SERVICE INFORMATION BULLETIN

APPLICABILITY: 2019MY Forester

NUMBER: 07-142-18

SUBJECT: Battery Sensor Removal and Installation Precautions

Plate (a) shown in proper position with the rotation stopper tabs (b).

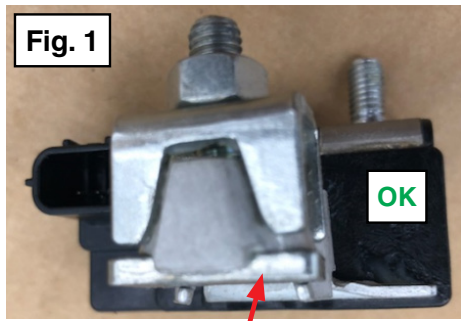
- If the sensor needs to be removed, loosen the 10mm hex nut **only as much as needed** to remove it from the (-) battery post. This way, the bottom plate (a) will stay in the proper position on the underside of the wedge / clamp portion as shown in **Fig. 1** below. If the nut is loosened too far like in **Fig. 2**, the plate can get out of alignment with the rotation stopper tabs (b) as shown in **Fig. 3**. If an attempt is made to reinstall the sensor with the plate out of position, the sensor will be damaged and require replacement.

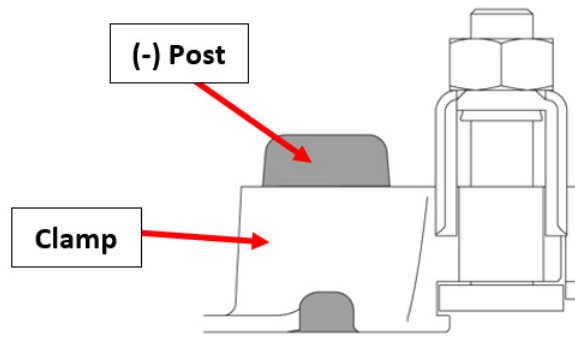
- When installing the sensor assembly onto the battery post, confirm it is fully seated and the (-) post protrudes above the clamp portion as shown below before torquing the 10mm retaining hex nut.

- Negative Battery Cable (Ground) Nut: 7.5 Nm (**5.5 ft. lbs.**)
- Terminal Clamp Nut: 6 Nm (**4.4 ft. lbs.**)
- Always hold the sensor in place with one hand while loosening or torquing either 10mm hex nut.
